AIRPORT FUEL FARM DESIGN

Enel Farm Design Review

Airport Fuel Farm Plans Review

Bulk Fuel Storage and Dispensing System, Addison Airport
The “Bad Boy” list as of 7-26-04:

**ADDISON FUEL SYSTEM
PRELIMINARY SITE PLAN**

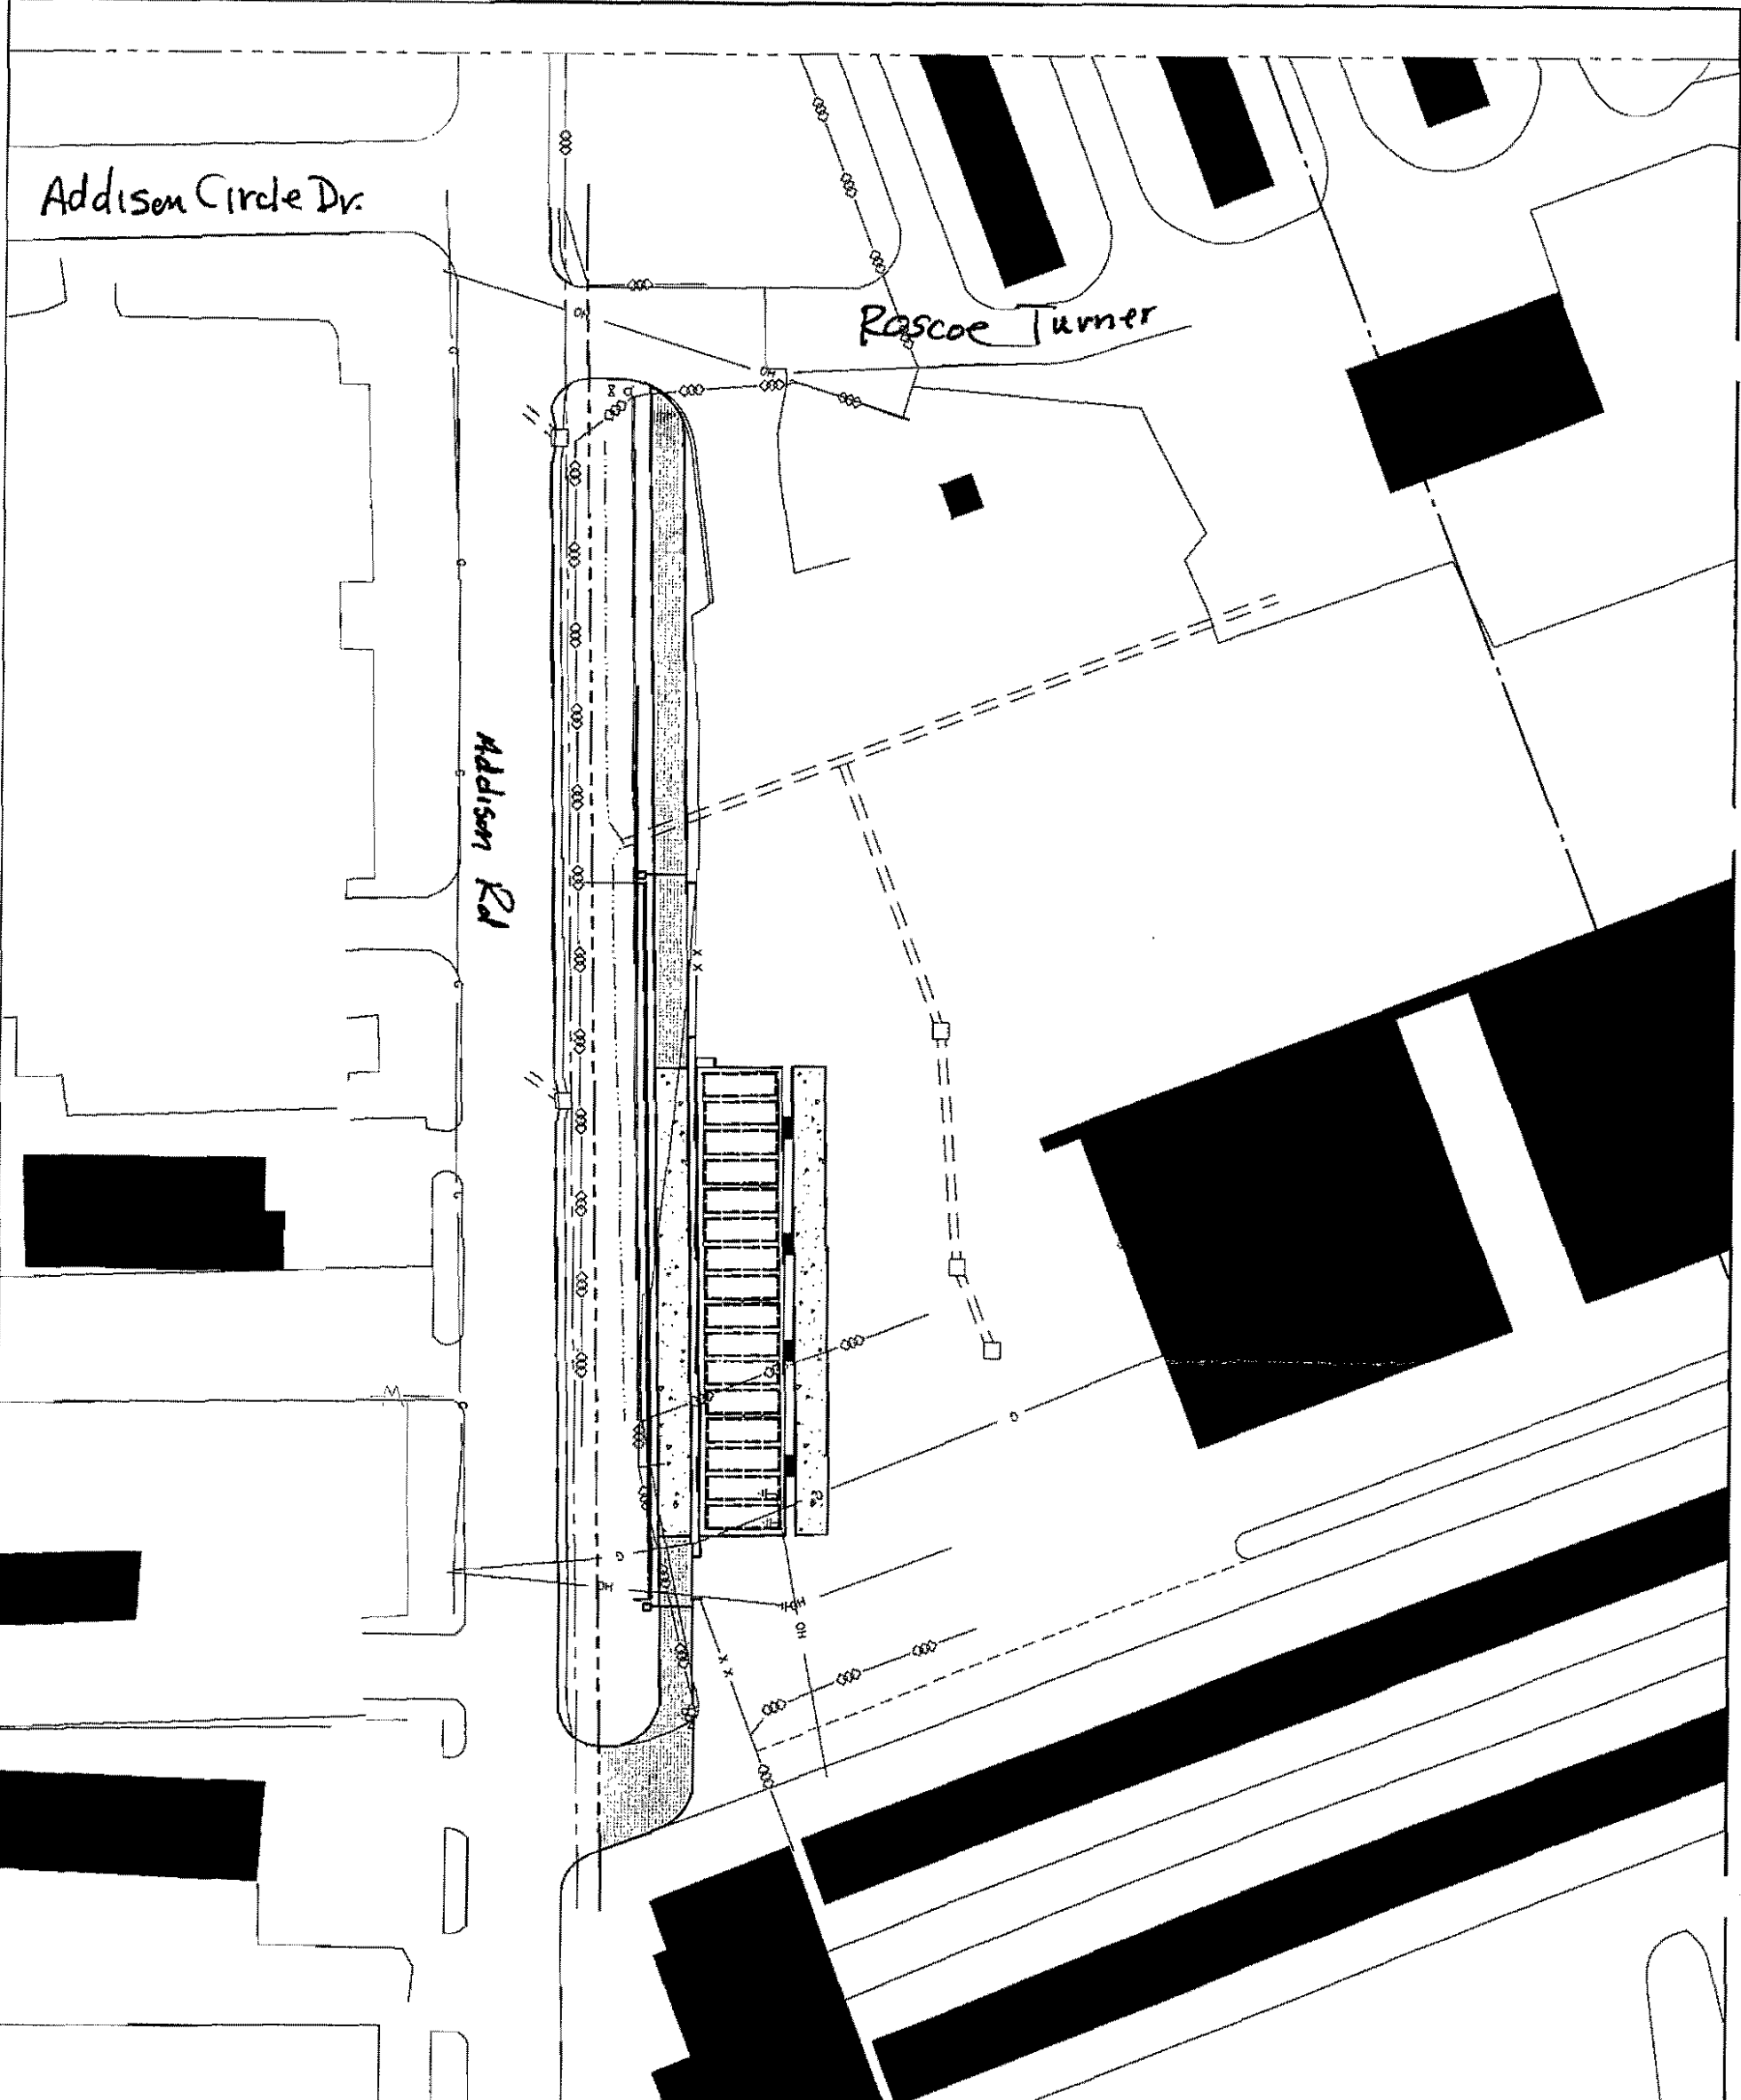
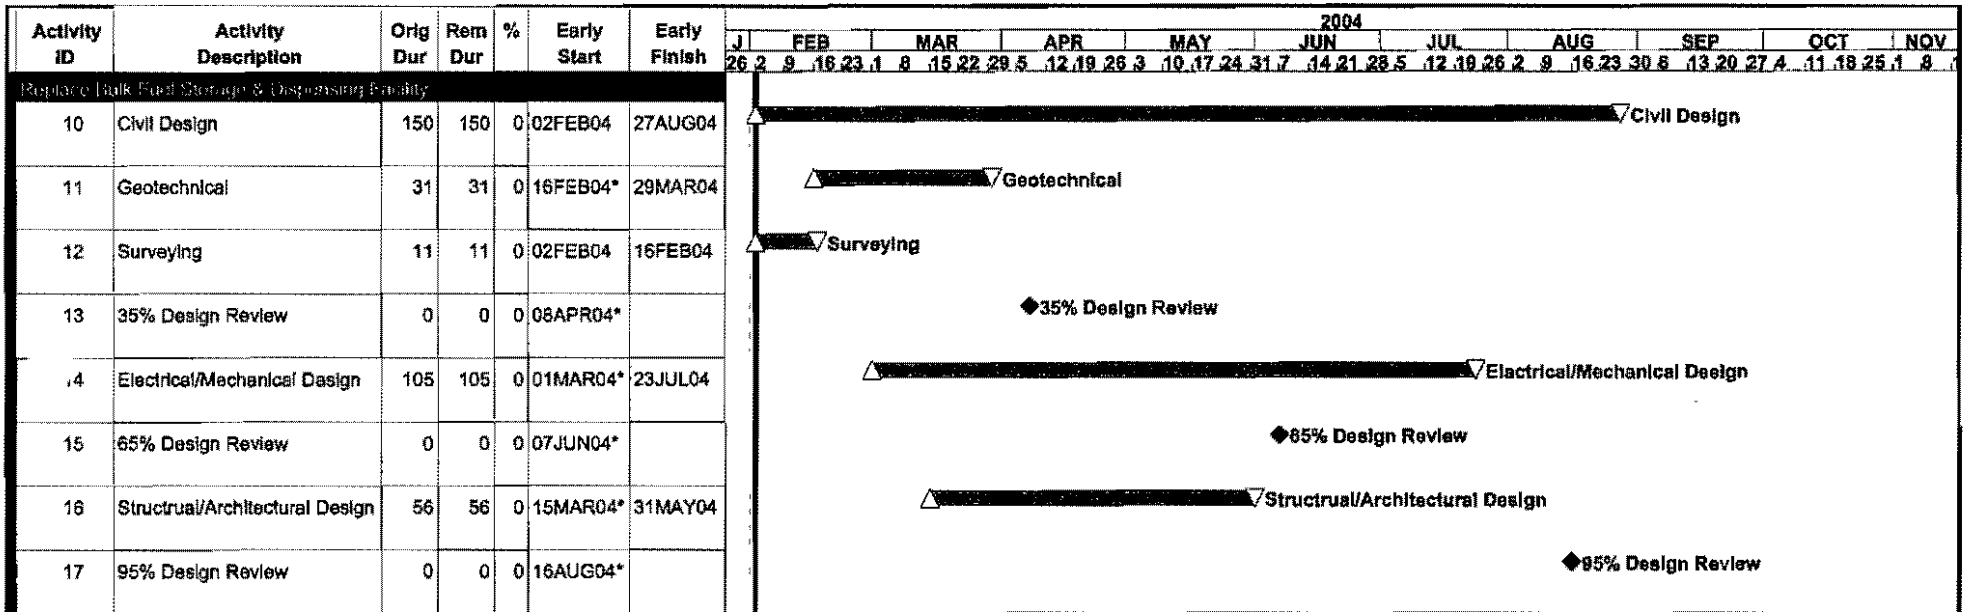
Need 20' each side
 Space -
 I need to know
 if we plan to
 take any fuel
 from the airport
 along Addison
 Rd when we
 go to S
 please you
 should have a
 set of plans that
 get to please
 show first.
 Jim
